SECTION 00 9111
ADDENDUM NUMBER 01

DATE: August 19, 2024

PROJECT: S-29 Miller Armory Latrine Addition

PROJECT NUMBER: 2112209640

P100

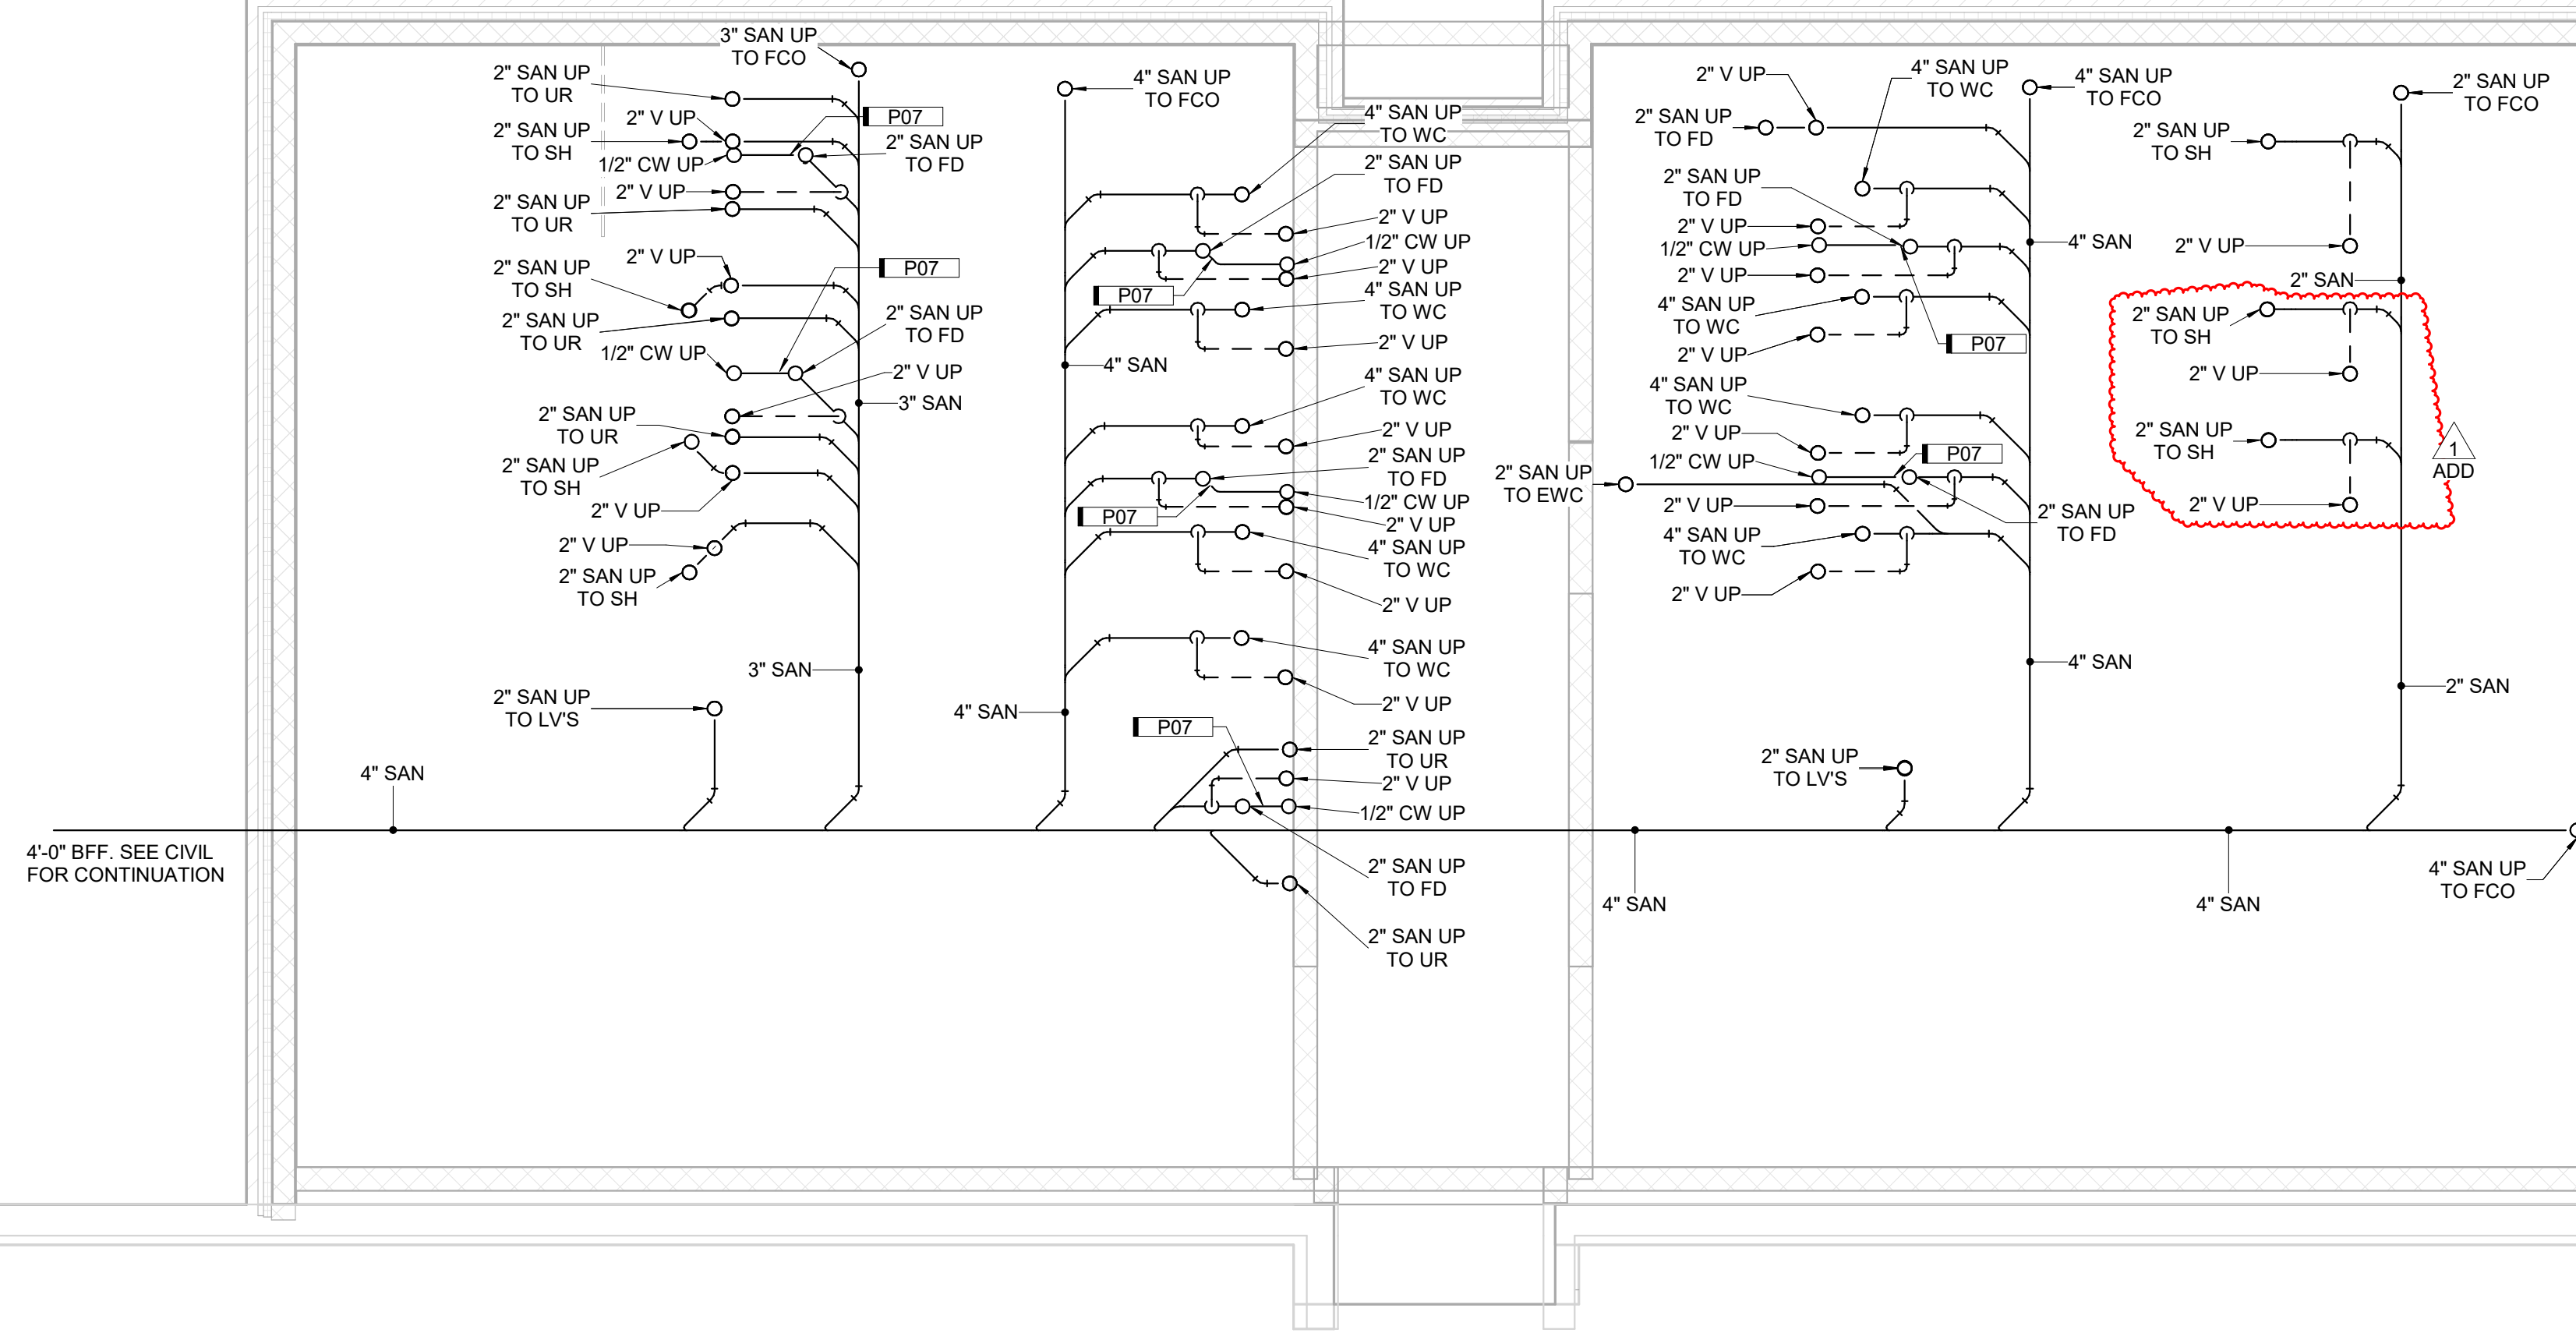
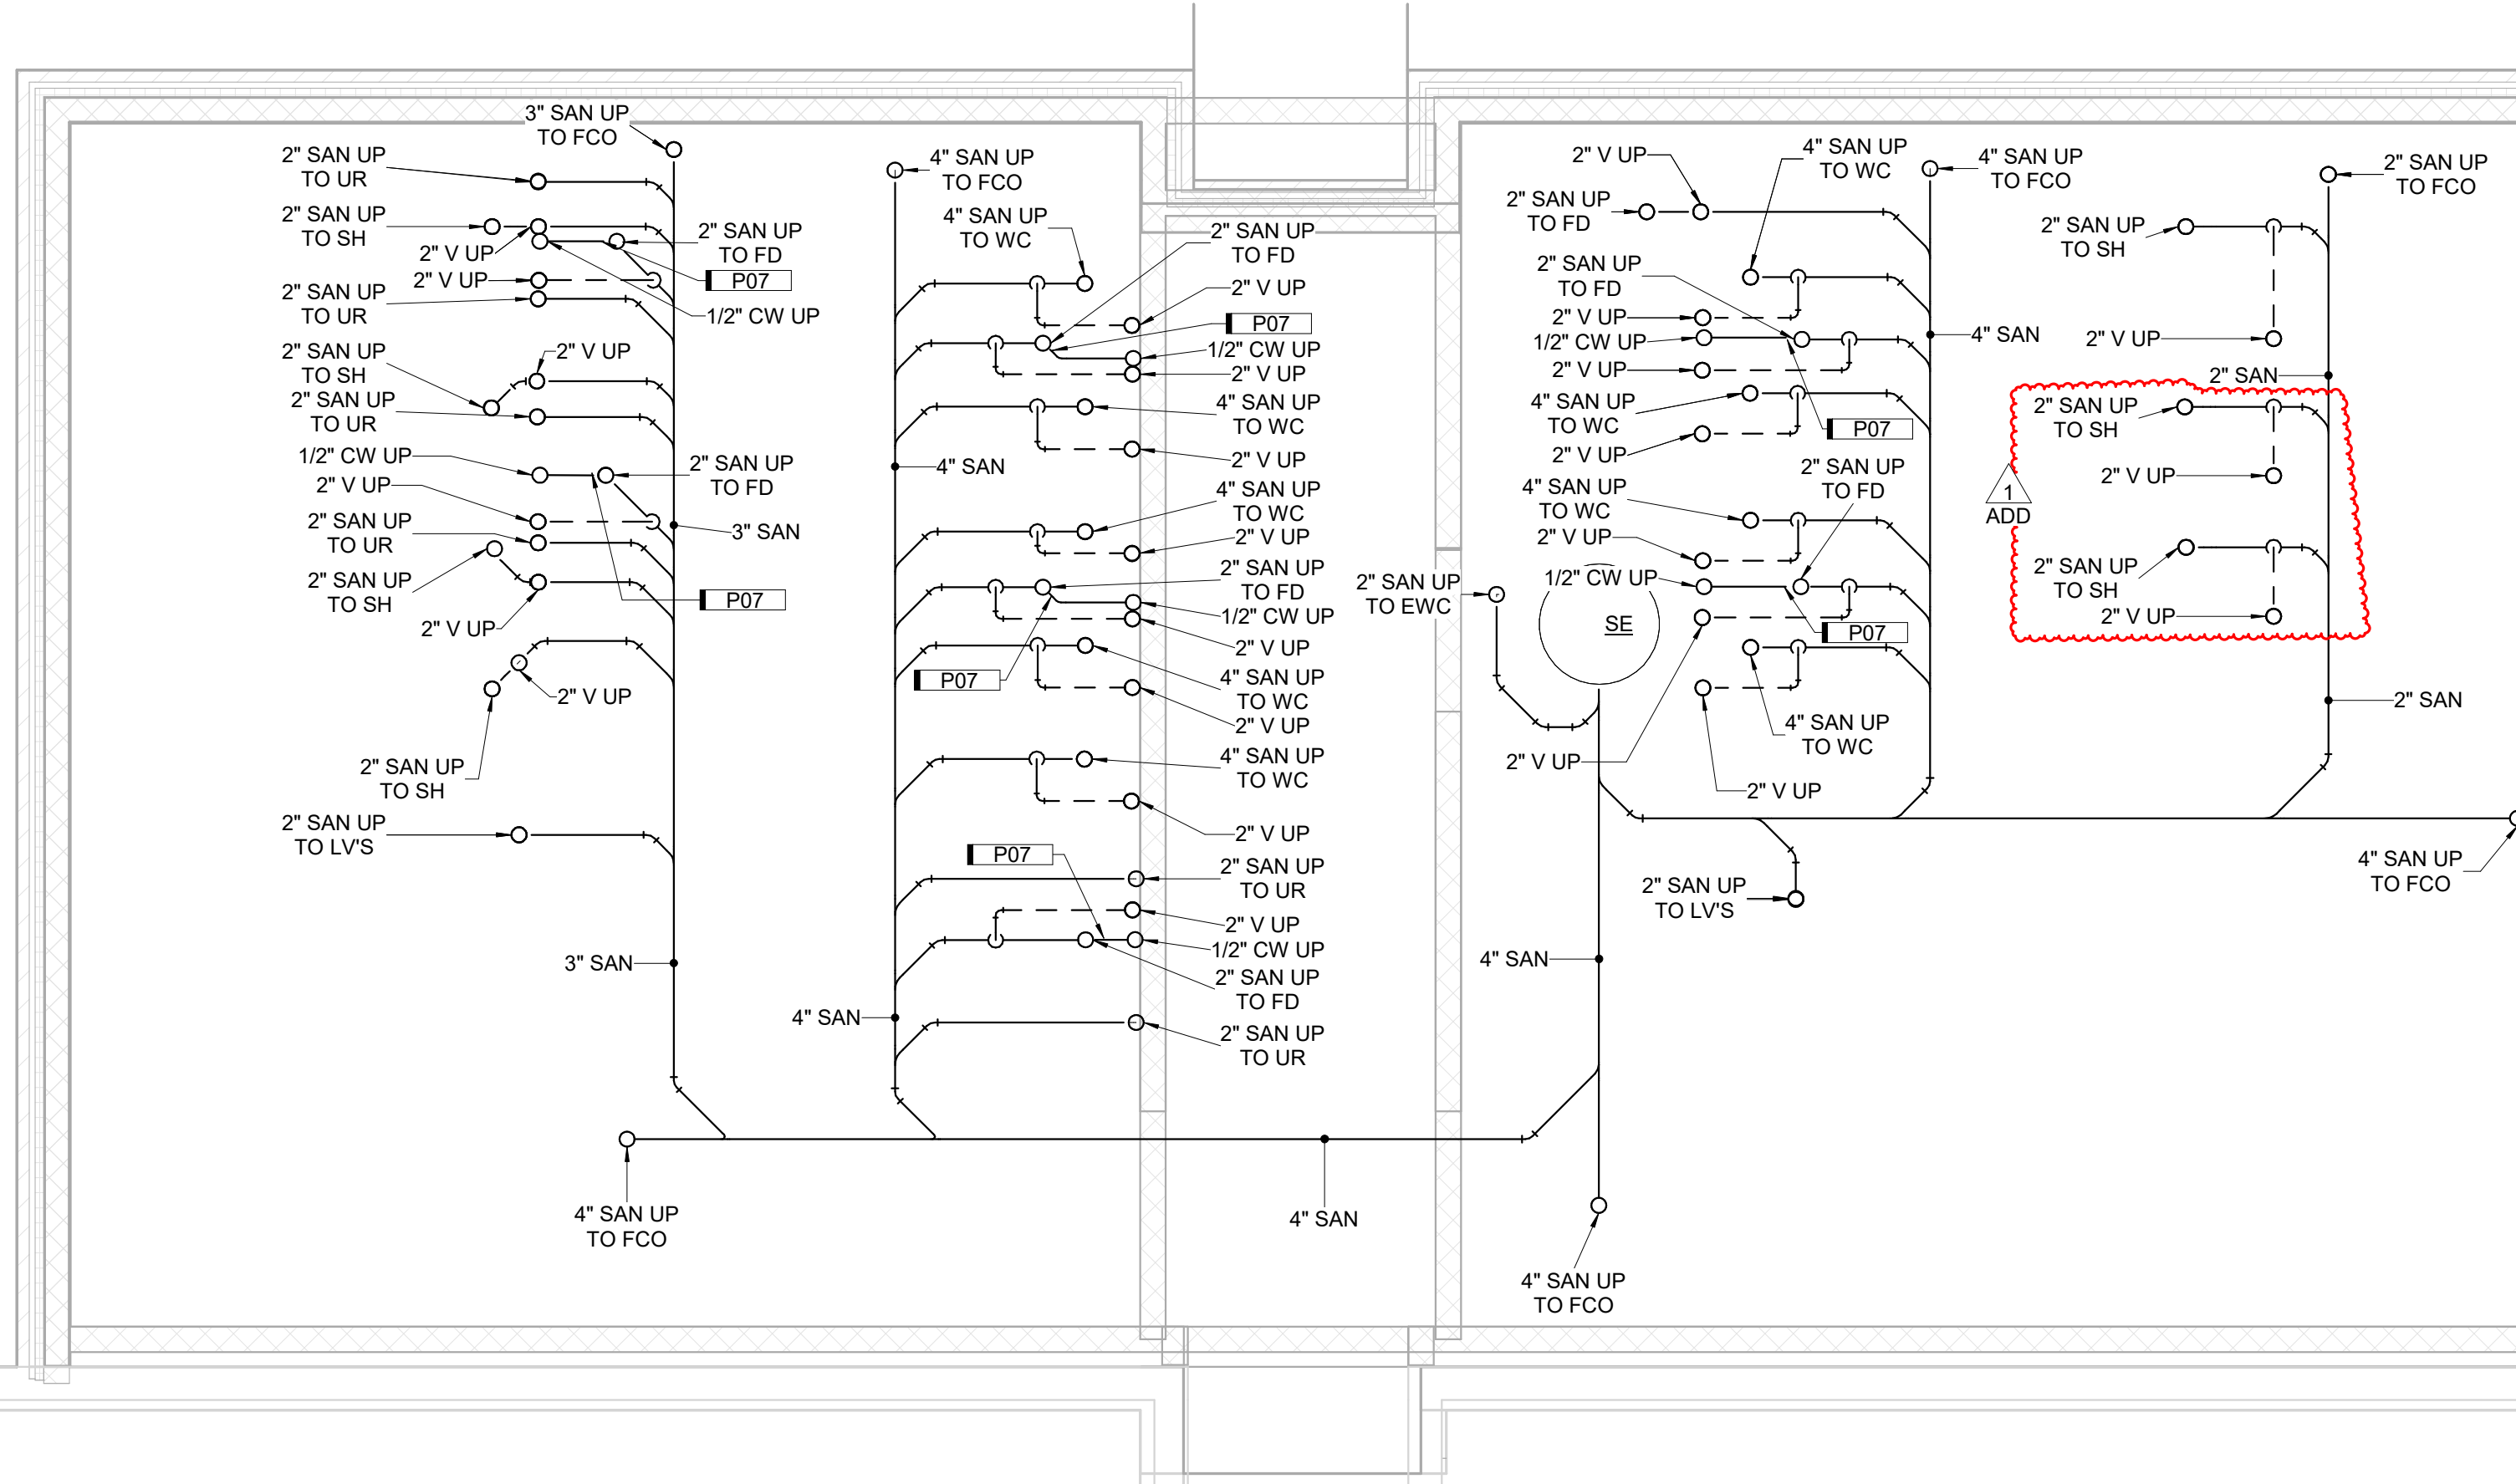
1. **REVISE** the sanitary and vent piping to the showers in the women’s shower area.

A4 LEVEL 1 STORM, SANITARY AND VENT PLAN
 1/4" = 1'-0" 0' 6"

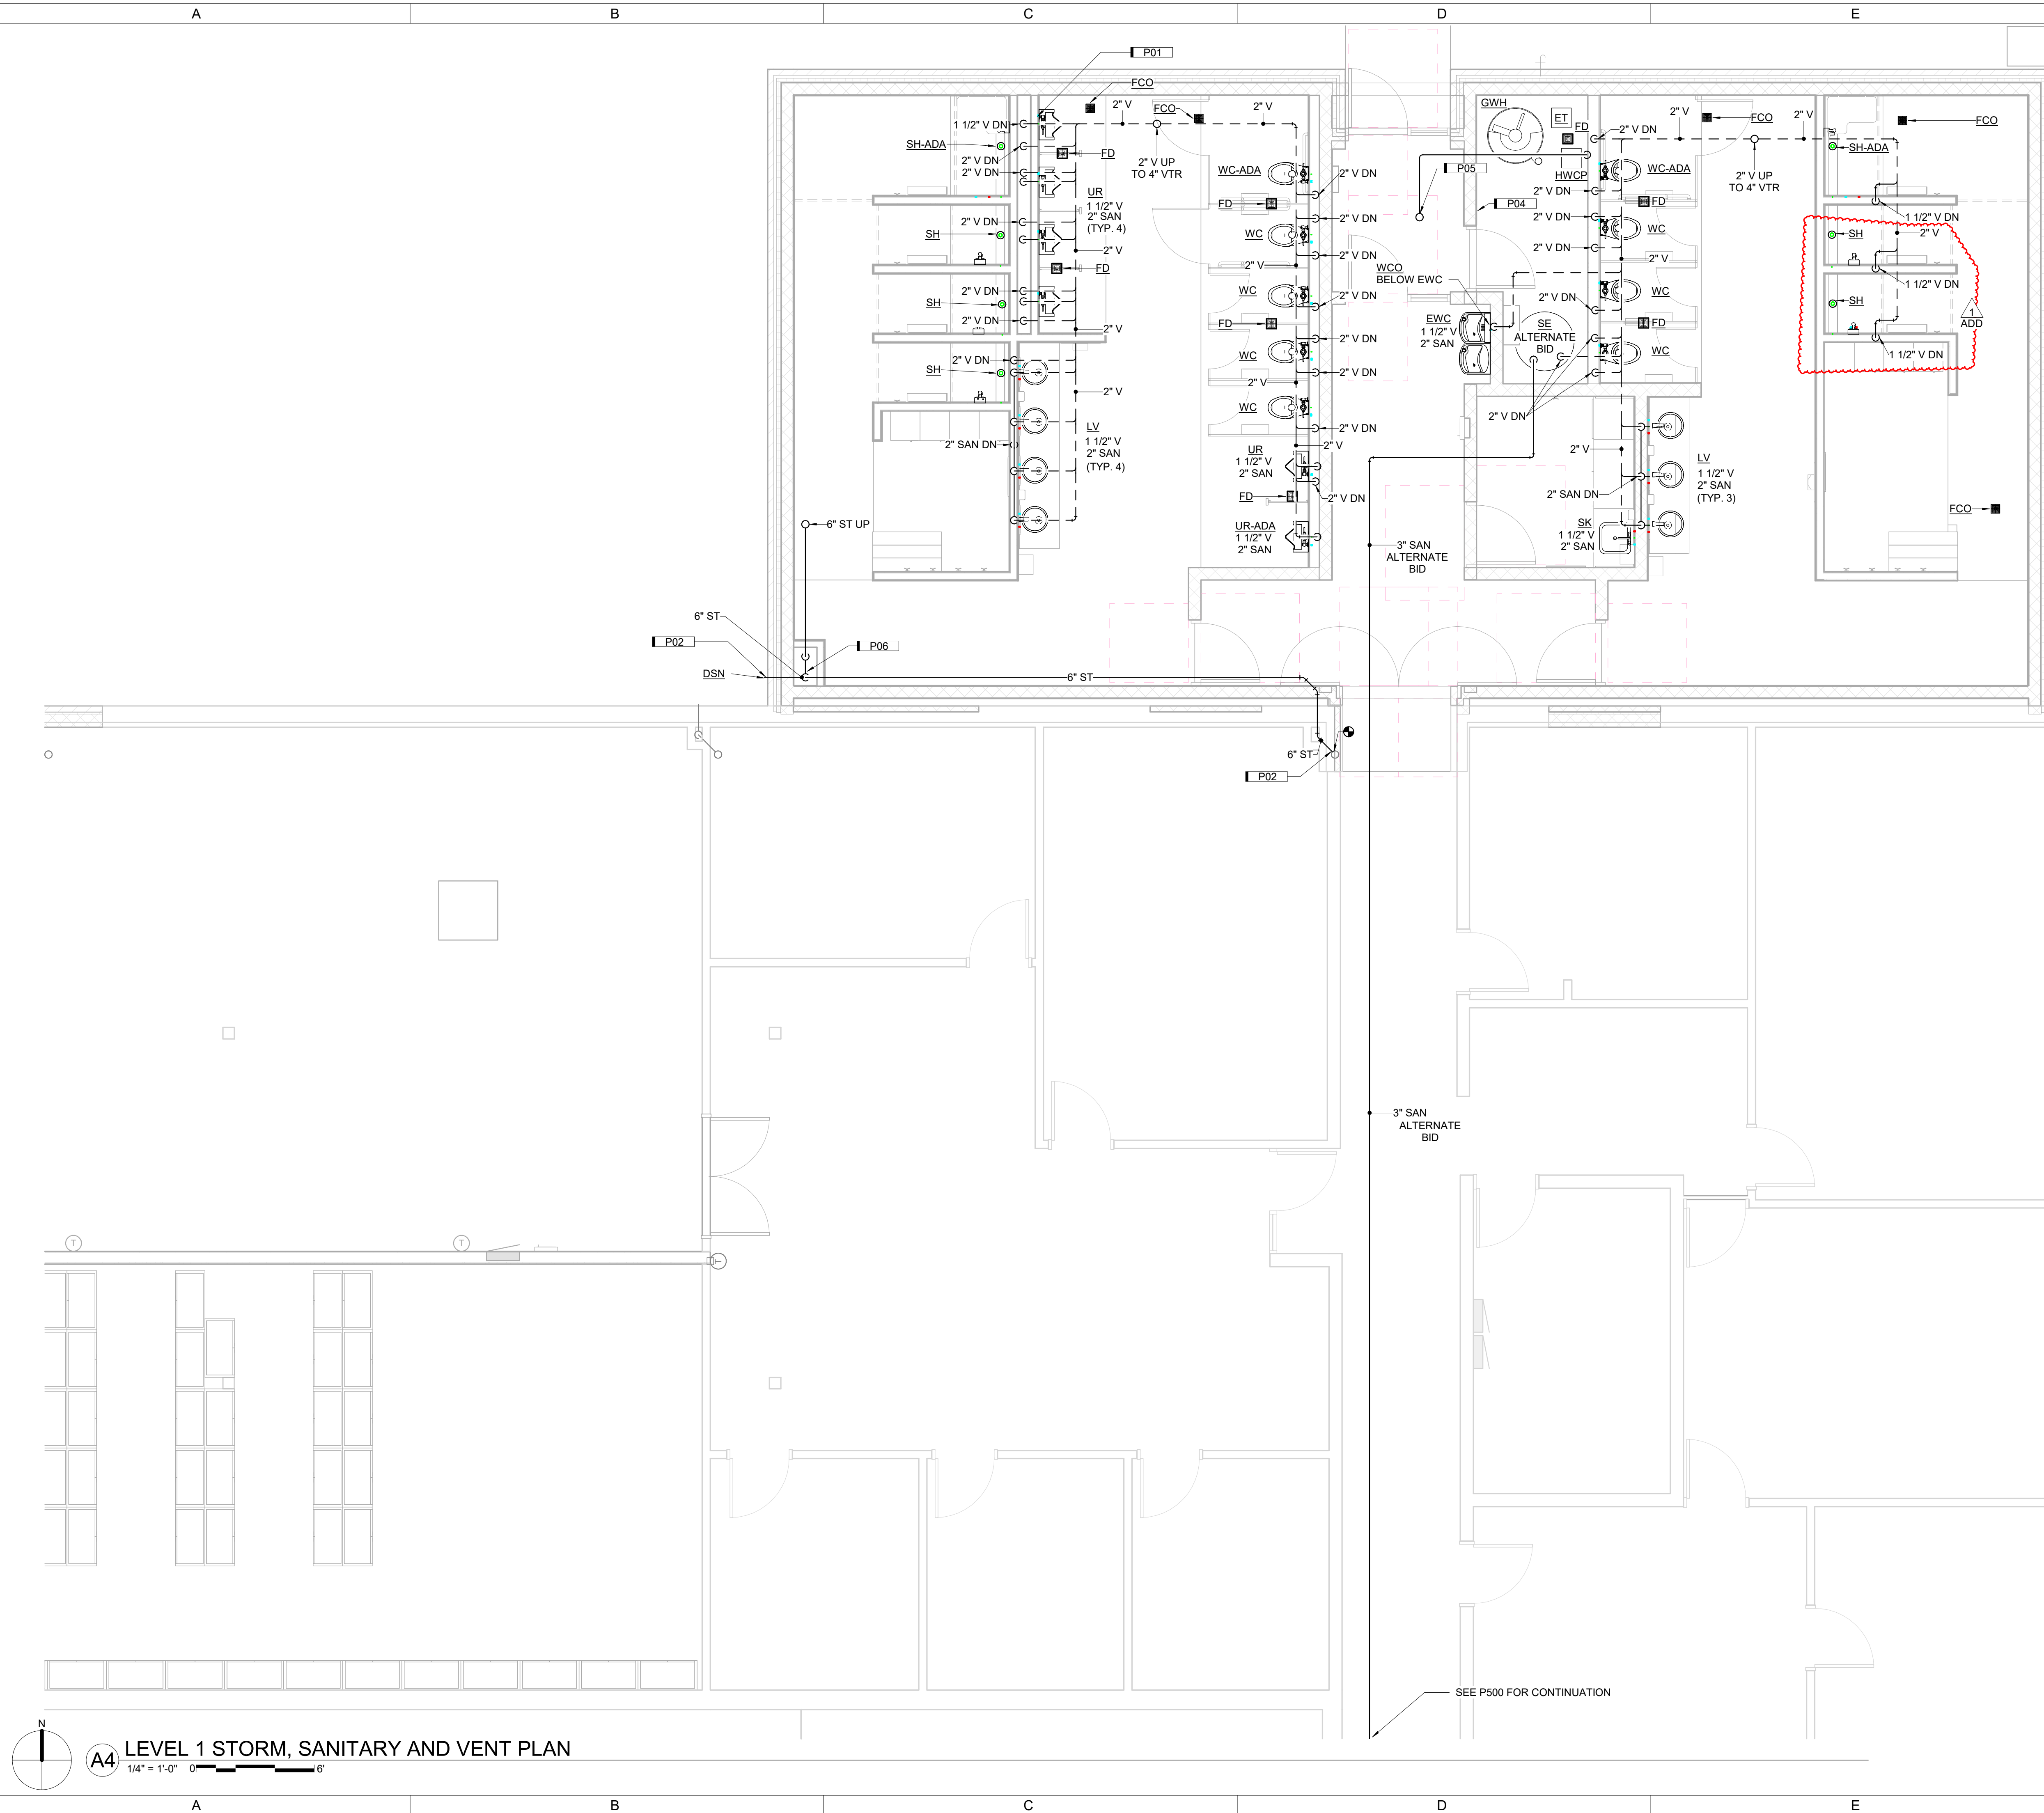
1. **REVISE** the sanitary and vent piping to the showers in the women’s shower area.
